SEWAGE DISPOSAL SYSTEM

P 57 0208-B

RE: Septic Repair
Fritz Kulla Property
7349 Brown Bridge Road

Low Pressure Dosing, Shallow Trench Design Sewage Disposal System

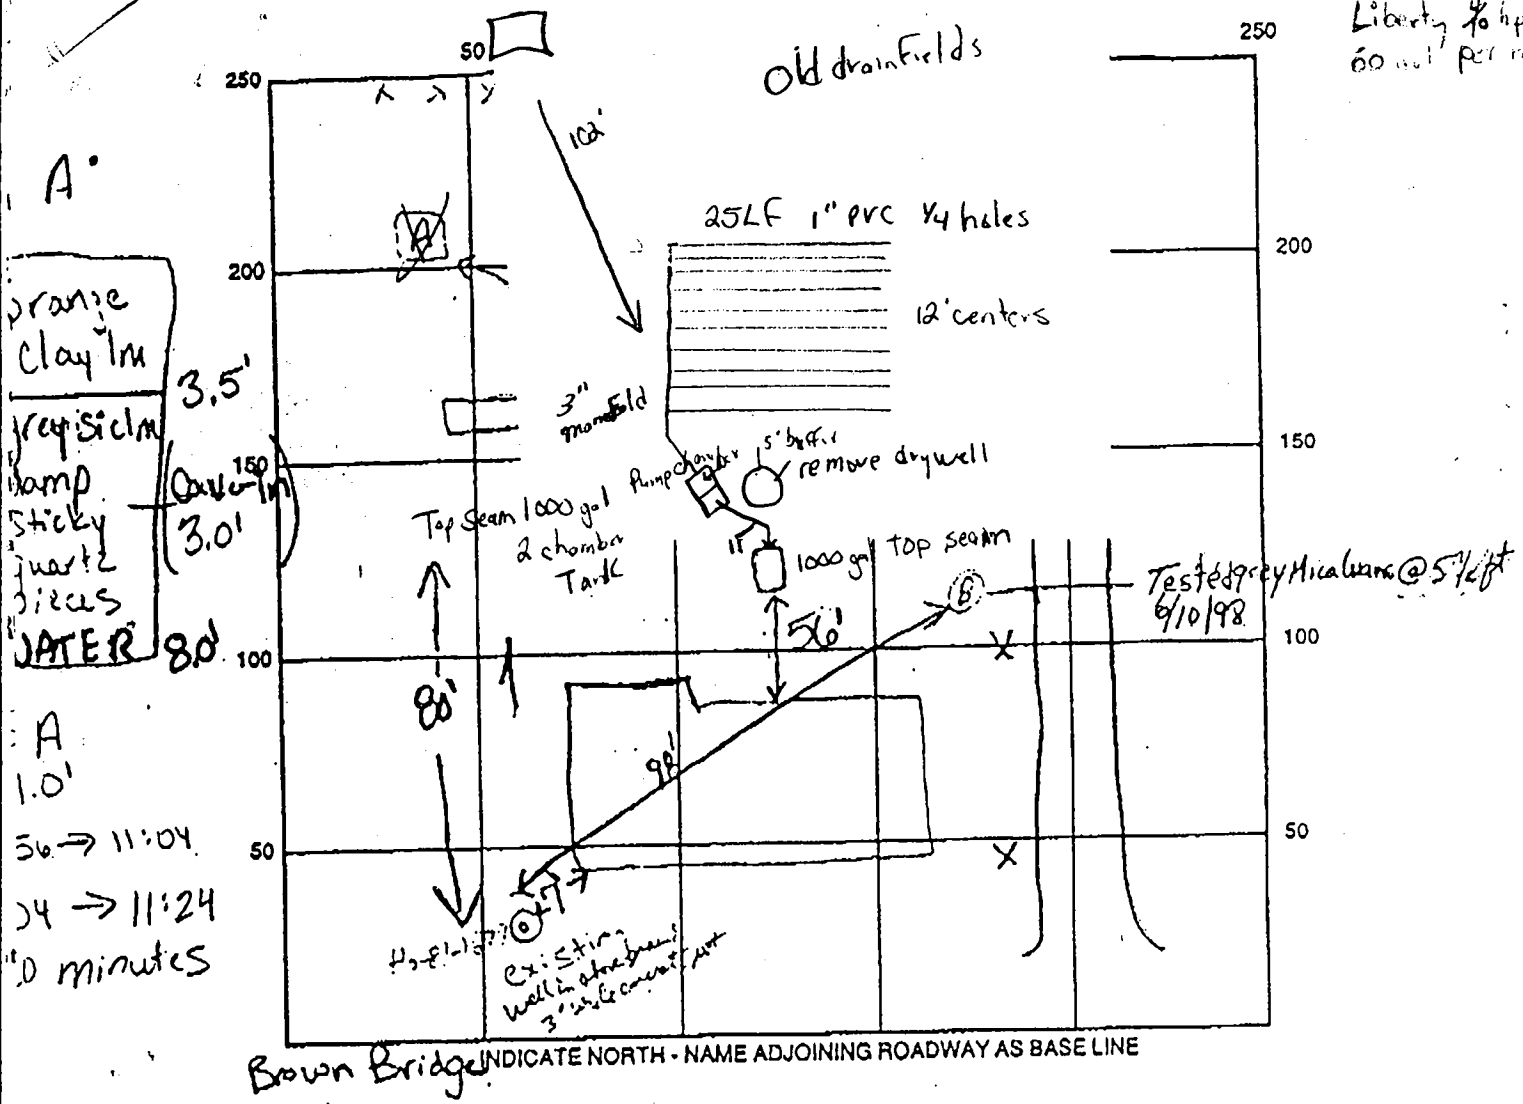
REMARKS: 6-8-98 New septic tank installed and connected to house and existing drywell, drywell pumped by Hatfields; due to questionable soil conditions site will need further evaluation by senior sanitarian on Weid's 6/10/98 to determine the type of repair (RM)
7/2/98 HOMEOWNER WISHES TO RECONNECT EXISTING SYSTEM
AT THIS TIME RATHER THAN CONTINUE WITH INSTALLATION OF NEW DISPOSAL FIELD (C)

Low Pressure Dosing, Shallow Trench Design Sewage Disposal System

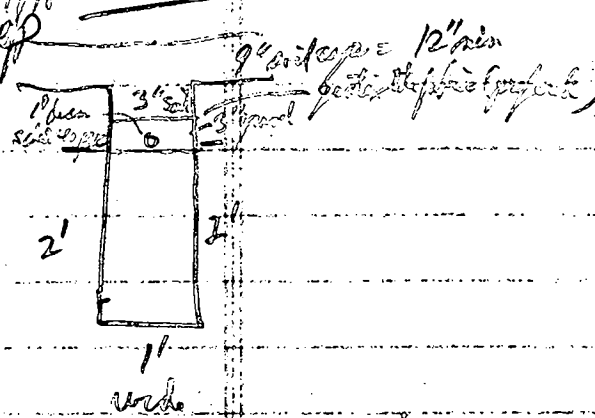
Assume 3 bedroom house equals 450 gal per day daily sewage flows. Install a total of 250 linear feet of trench. Each lateral trench to be 25' long, 1' wide, 2-1/2' deep, 2' of gravel under 1" diameter schedule 40 (or SDR equivalent) lateral piping. Place 2" gravel cover over 1" pipe, then geotextile fabric cover, then topsoil fill. A soil cap should be at least 12" deep over geotext tile fabric and extend at least 10' in all directions past the drain field layout.

Design soil loading rates are 0.45 gpd/sq ft of effective sidewalls (use both sidewalls only). Because soils at 3' and greater have much lower percolation rates (denser soil structures and textures), the trenches need to be spaced over a basal area of at least 3,000 sq ft. This means at least 12' center to center spacing between trenches and 5' undisturbed soil spacing between trenches where the manifold lines are placed (i.e. 0.15 gpd/sq ft over the basal area). With 1" diameter lateral piping, hole perforations should be 1/4" diameter and 5' spacing apart along each trench (i.e. 5 perforation, per 25' lateral). Force main and manifold should be 3" diameter piping using a center feed design. Top seamed 2 chambered septic tank and a top seamed pump chamber are required. The existing top seamed tank may be used for whichever function it can more readily assume. The above system design is for site number 2 (the one closest to the house).

The design assumes full dosing of all trenches at each dosing cycle. A preferred method to lengthen the system's functional life is to alternate dosing cycles. Only half the trenches are dosing in one cycle (i.e. all even number trenches), this set then rests the next dosing cycle while the odd numbered trenches are dosed. Since only alternating trenches are in use at any given time, spacing between trenches may be reduced to 7' center to center (i.e. 14' center odd to odd, or even to even number trench).

Site number 1 with mottling and denser soils less than 2' below grade, and water grey soils at 3' below grade is more suitable for sand mound system design than any type of in ground system. If a in ground system were contemplated at site number 1, only 1' deep (maximum) trench could be used. Therefore, double the above total trench length (i.e. 500 linear feet) would be required and enhanced pretreatment and timed dosing and alternating cycle dosing is strongly advised.

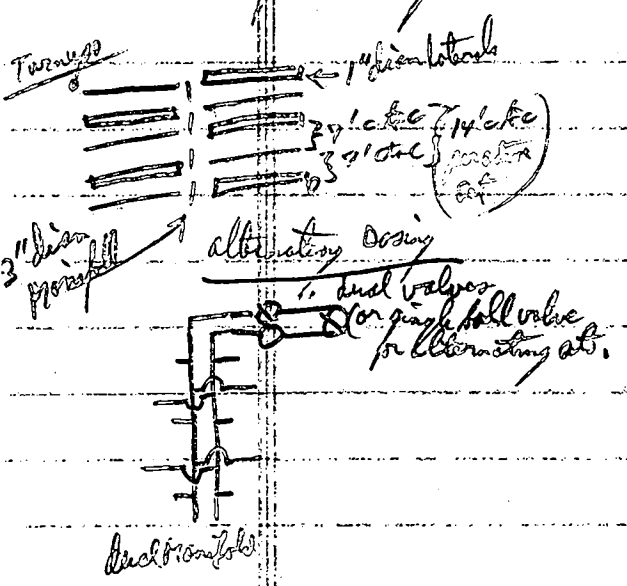
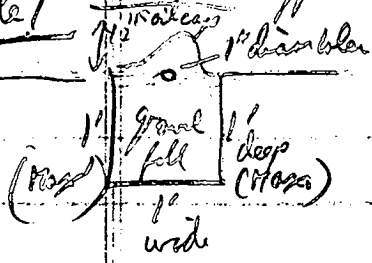
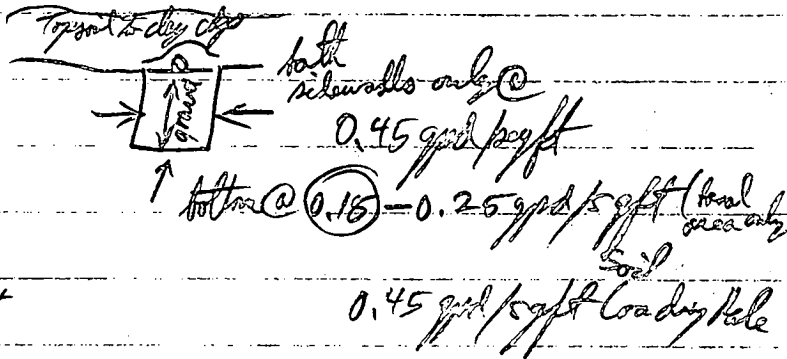
5 1/2 ft to grey soil (containing table)
 slower soil zone depth @ 22 ft (use 15 gpd/100 ft basal area)
 = 3000 gal/acre (Min basal area)
 ÷ 250 L/ft trench = 12 ft trench spacing

30" Max Depth
 24" stone fill under pressure pipe
 [2' effective soil width x 2 actuals = 4 sq ft effective soil width
 x 15 gpd/sq ft = 1.8 gpd/lineal ft of trench]

Design 400 gpd
 ÷ 45 gpd/sq ft = 1000 sq ft effective area
 1000 ÷ 4 sq ft = 250 L/ft of trench
 = 10 Trench x 25' long each
 center manifold design

gravel
 20" vs 24" gravel fill under trench
 = 40" total = 3.33 sq ft effective soil
 vs 4 expression

Not to proceed (Better to hold this area for future sandboxed design when applicable) - say trench would destroy site for future use.

- 12" max depth
- 12" gravel fill
- 12" Trench width
- 1" diameter laterals
- 1/4" diameter perforations

design 450 gpd / 1000 sq ft
 $\div 45 = 2 \text{ gpd/sq ft}$
 $= 500 \text{ lin ft of Trench}$
 $\div 25 \text{ ft long laterals} = 20 \text{ Trenches total}$
